SUBJECT: Savannah River Site's Responses to the Regulatory Comments on the Effectiveness Monitoring Report (EMR) for the C-Area Groundwater (CAGW) Operable Unit Removal Action (U) April 2019 through June 2020 (SRNS-RP-2020-00566, Revision 0, September 2020) SEMS Number: 82

SRS Responses to South Carolina Department of Health and Environmental Control Comments on: Effectiveness Monitoring Report (EMR) for the C-Area Groundwater (CAGW) Operable Unit Removal Action (U) – April 2019 through June 2020, SEMS Number: 82 (SRNS-RP-2020-00566, Revision 0, September 2020) received October 6, 2020.

SRS Responses to EPA Comments on the Effectiveness Monitoring Report (EMR) for the C-Area Groundwater (CAGW) Operable Unit Removal Action (U) – April 2019 through June 2020, SEMS Number: 82, SRNS-RP-2020-00566, Revision 0, September 2020, Savannah River Site, South Carolina

Figure 2 Revised for Inclusion in 2021 EMR

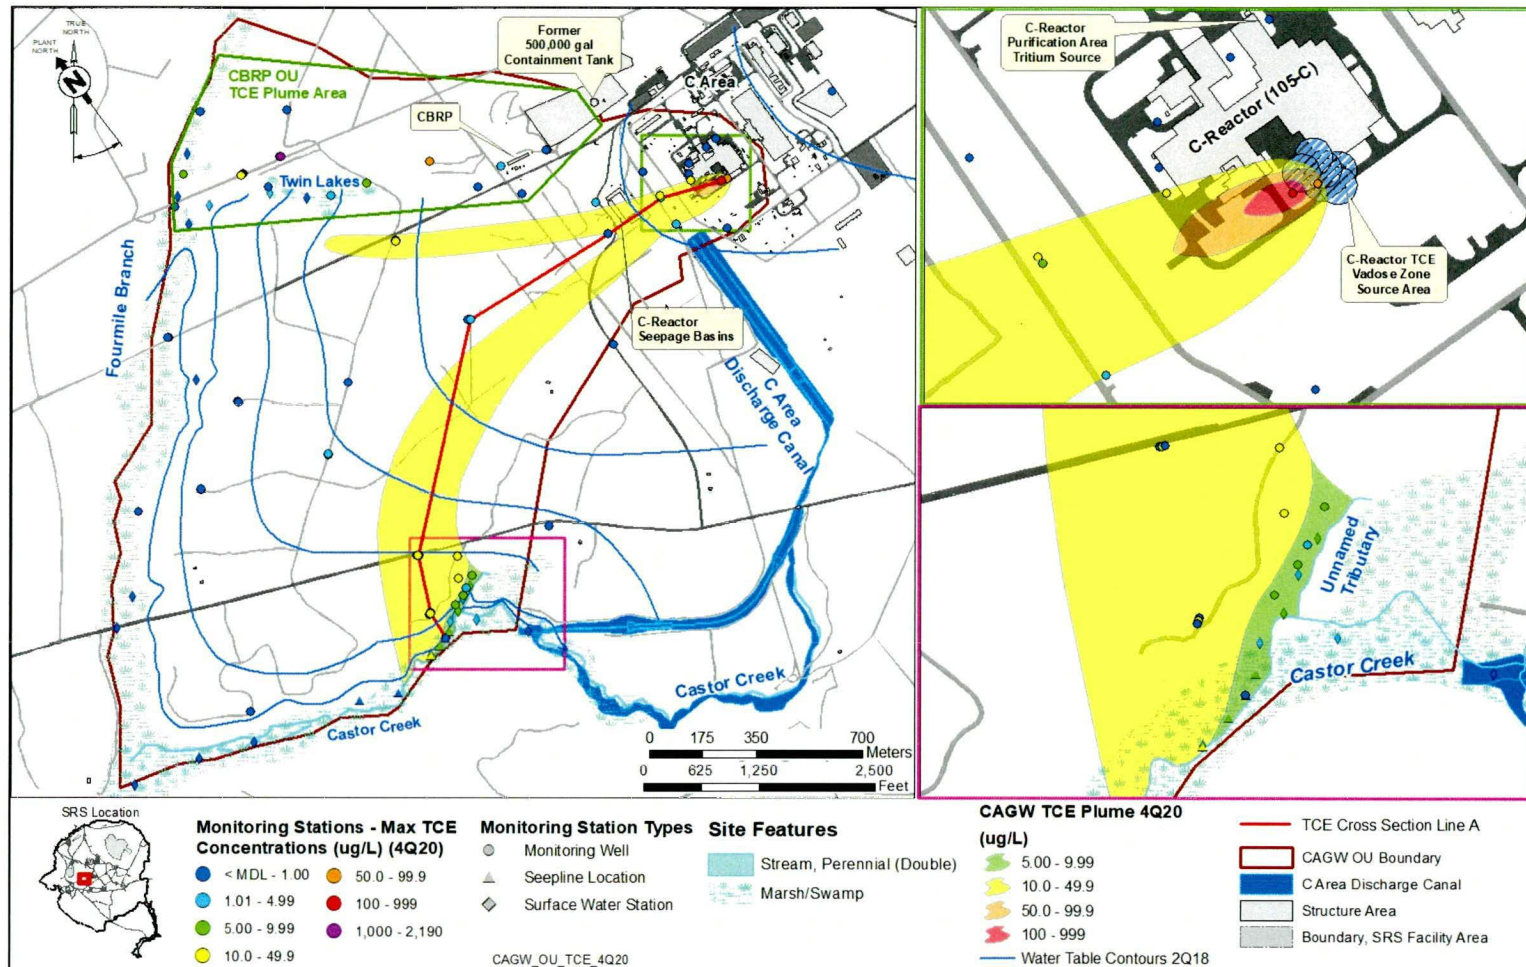
1. Section 2.0, Operable Unit Description and History, page 1. The first paragraph of this section lists known sources associated with reactor operations that have resulted in tritium and VOC contamination in groundwater at CAGW OU. Please update one of the figures in the report to include these source locations or provide a separate figure depicting them.

Response: Agree.

Figure 2 will be revised in the 2021 report to show the locations of these source areas, similar to the revised Figure 2 attached to these responses. No changes are proposed for the 2020 Effectiveness Monitoring Report.

Figure 3 Revised for Inclusion in 2021 EMR

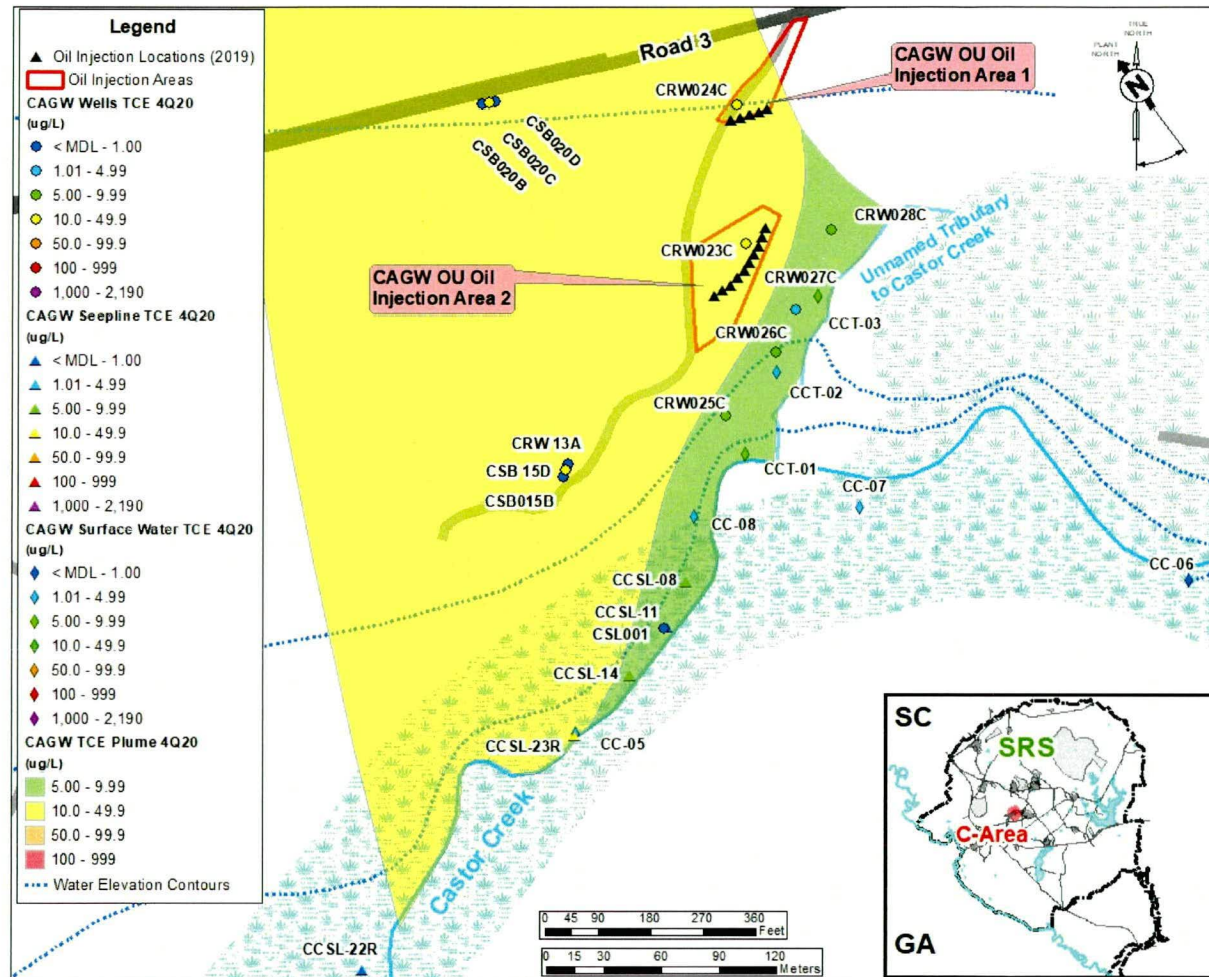
2. Figure 3, CAGW OU NTC RA Areas (Baseline Conditions), page 29 and Figure 6, CAGW OU Monitoring Stations, page 35. Figure 3 depicts monitoring well CRW 15A grouped with CSB 15D and CSB015B, yet Figure 6 shows monitoring well CRW 13A at this location instead. CRW 15A is shown on Figure 6 downgradient of this cluster with wells CRW015B and CRW 15C/D. Please revise the figures as appropriate.

Response: Agree.

Figure 6 has the wells correctly labeled, and Figure 3 will be revised in the 2021 report with well CWR 13A labeled correctly, similar to the revised Figure 3 attached to these responses. No changes are proposed for the 2020 Effectiveness Monitoring Report.

Figure 1-2 from the U.S. Air Force Protocol for In Situ Bioremediation of Chlorinated Solvents Using Edible Oil

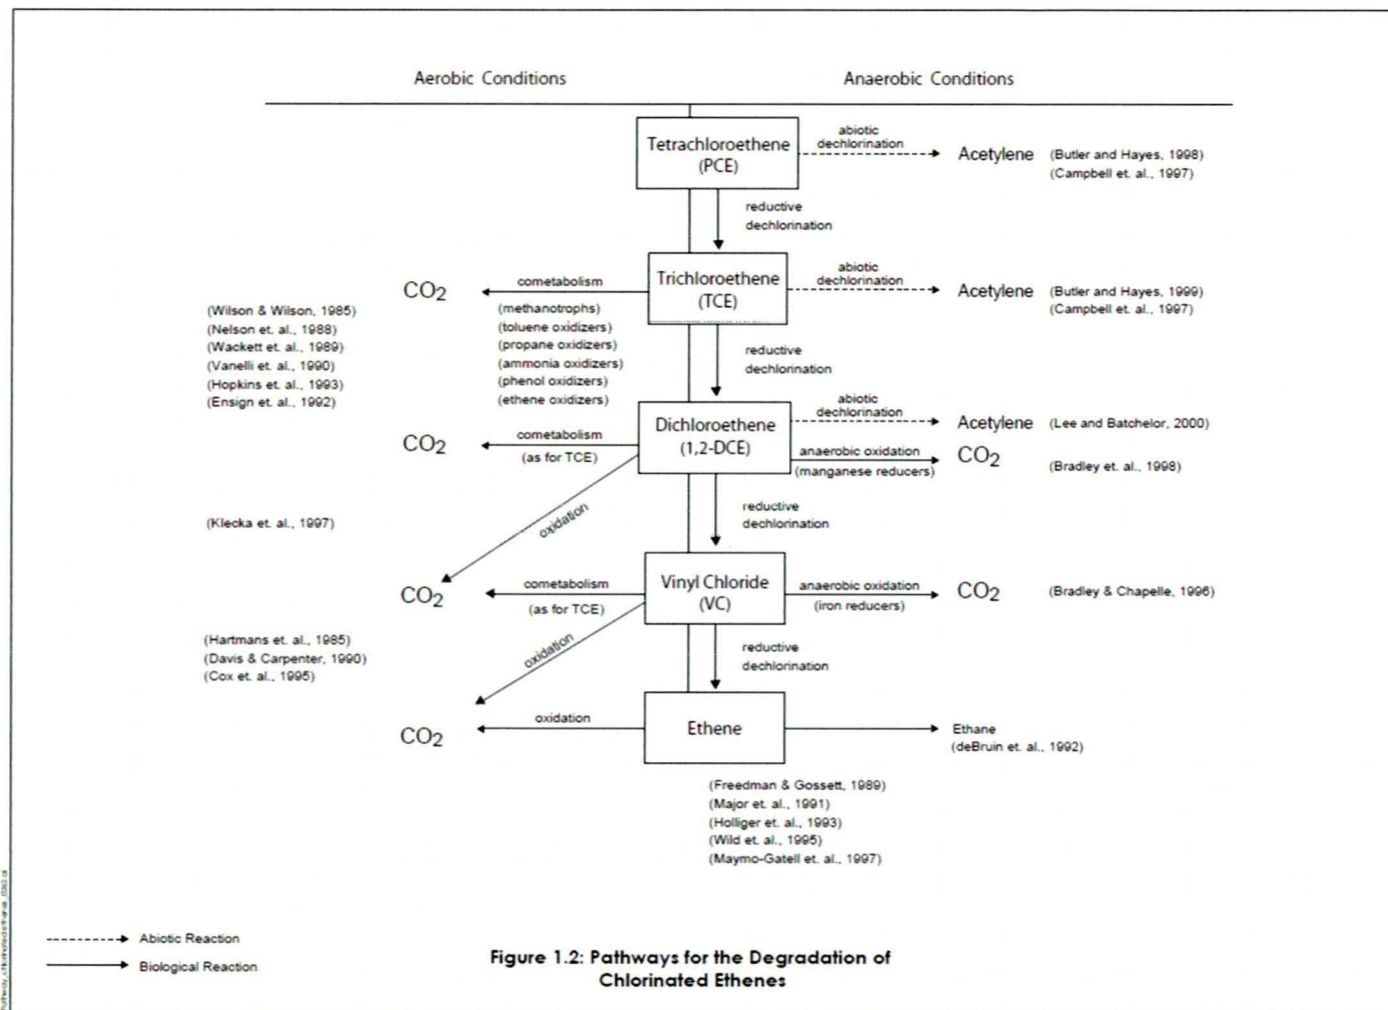
3. The significance of the aerobic biodegradation pathway and its impact on cis-1,2-dichloroethylene (DCE) and VC were not discussed in the EMR. It is noted that the biodegradation of cis-1,2-DCE and VC can occur via the aerobic pathway and the BioTrap sampling indicted the presence of aerobic microbes and related enzymes. Currently, the CAGW OU NTC RA monitoring results indicate concentrations of cis-1,2-DCE and VC are virtually non-detect at all sampling locations. Revise the EMR to discuss the significance of aerobic biodegradation on reducing concentrations of cis-1,2-DCE and VC.

SRS recognizes there are several pathways for the degradation of chlorinated solvents, including aerobic cometabolic degradation of TCE and daughters as indicated in Figure 1-2 from the *Protocol for In Situ Bioremediation of Chlorinated Solvents Using Edible Oil* (Air Force Center for Engineering and the Environmental, 2007) (See attached). This

could be the reason why cis-1,2-DCE and VC are not detected, and could be supported by the presence of aerobic microbes and associated enzymes. However, significant reductions in TCE concentrations were not observed. Additional interpretative text will be added to the 2021 EMR to address this potential pathway.

Figure 2 revised for inclusion in 2021 EMR

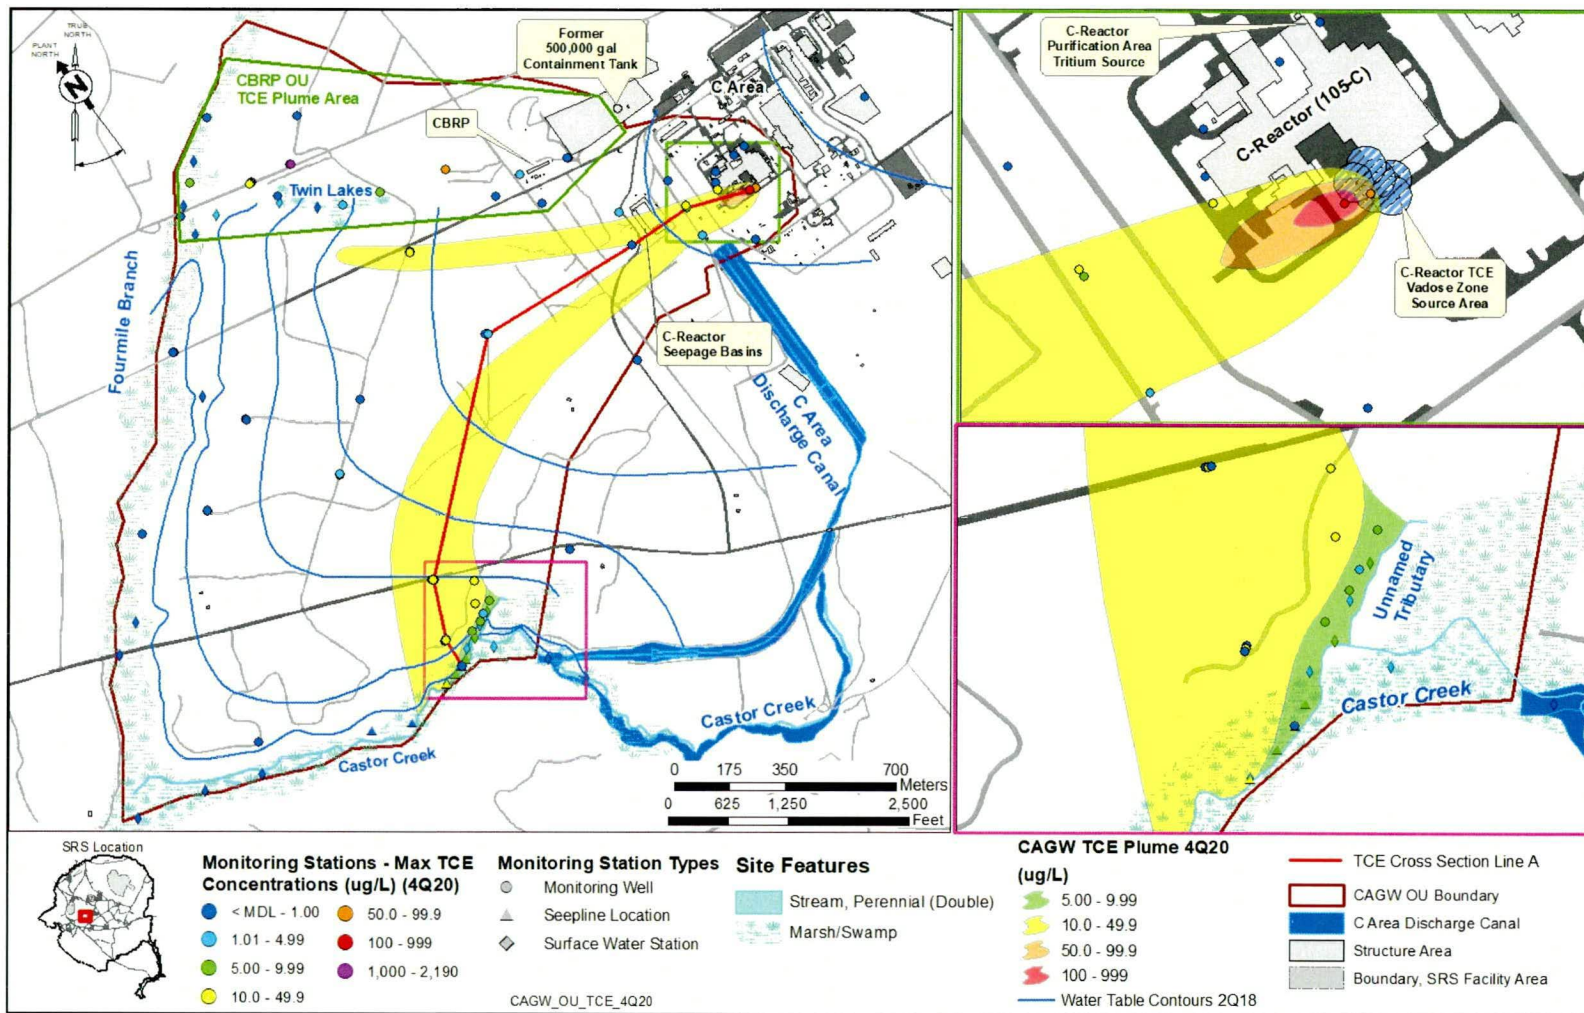
1. **Figure 2. CAGW OU TCE Plume 2019, and Figure 3. CAGW OU NTC RA Area (Baseline Conditions), Pages 27 and 29 of 100:** The most current TCE sampling results for the monitoring stations (i.e., monitoring wells, seepage wells, surface water stations) are not presented in the figures. As such, it is difficult to assess results relative to the TCE maximum contaminant level (MCL) of 5 micrograms per liter ($\mu\text{g/L}$) since up to 2 orders of magnitude is represented in a single range of concentrations. For example, in Figures 2 and 3, the orange colored symbols indicate a TCE concentration range of 5.00 - 99.9 $\mu\text{g/L}$ and 5.00 - 49.9 $\mu\text{g/L}$, respectively, representing two orders of magnitude. For clarity and completeness, revise the figures to include the most recent TCE data, and to split the concentration range of 5.00 - 99.9 $\mu\text{g/L}$ and 5.00 - 49.9 $\mu\text{g/L}$ into smaller increments, such as from 5.00 - 9.99 $\mu\text{g/L}$ and 10.00 to 99.9 $\mu\text{g/L}$ and 10 -49.99 $\mu\text{g/L}$, respectively.

Response: Agree.

Figures 2 and 3 will be revised in the 2021 report to show the most recent TCE concentrations, and smaller ranges will be used for the wells and plumes, similar to the revised Figures 2 and 3 attached to these responses. No changes are proposed for the 2020 Effectiveness Monitoring Report.

Figure 6 revised for inclusion in 2021 EMR

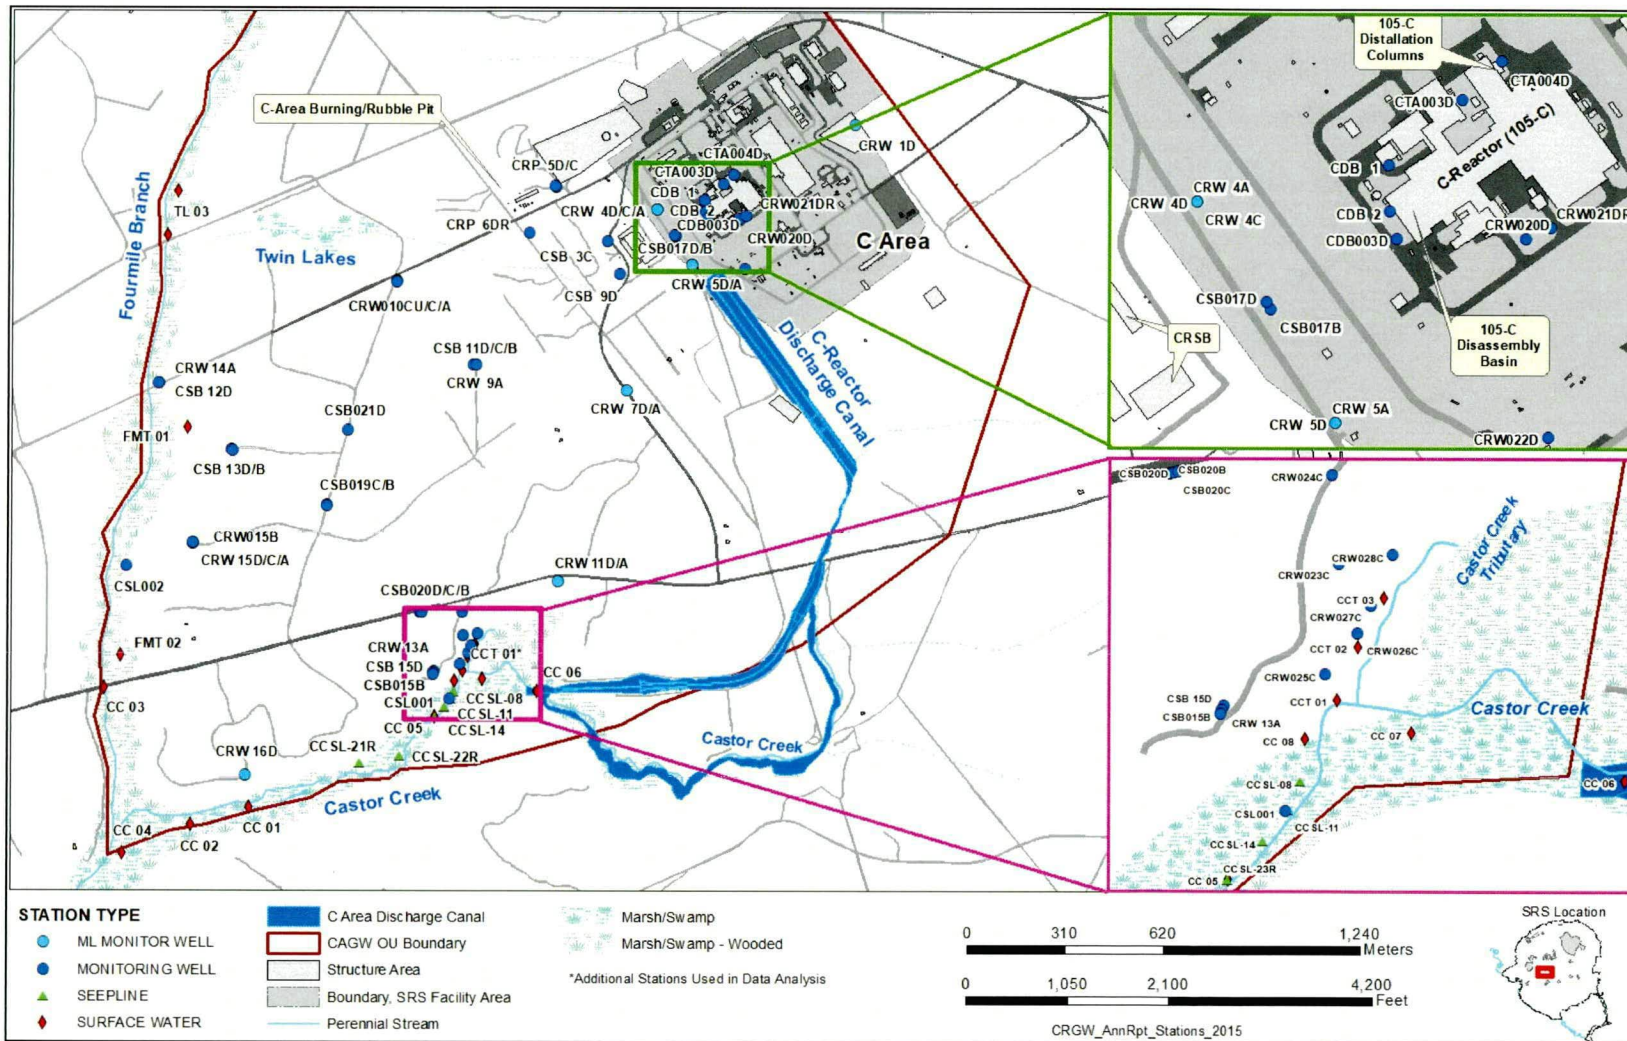
2. **Figure 6. CAGW OU Monitoring Stations, Page 35 of 100:** Castor Creek monitoring station CC-07 is not depicted in the figure. Revise the figure to illustrate the location of CC-07.

Response: Agree.

Figure 6 will be revised in the 2021 report to show the location of CC-07, similar to the revised Figure 6 attached to these responses. No changes are proposed for the 2020 Effectiveness Monitoring Report.
